Subject: BATTERY REPLACEMENT - SERVICE TIP	Bulletin No: 01-019/05
	Last Issued: 6/29/2005

2004-2005 RX-8

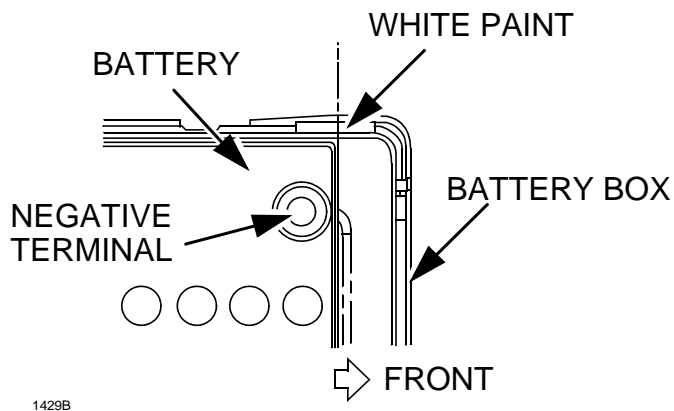
NOTE: Install battery as shown in illustration. Improper battery installation may reduce or eliminate airflow to battery. Installing a larger battery than specified may restrict airflow and reduce battery life or performance.
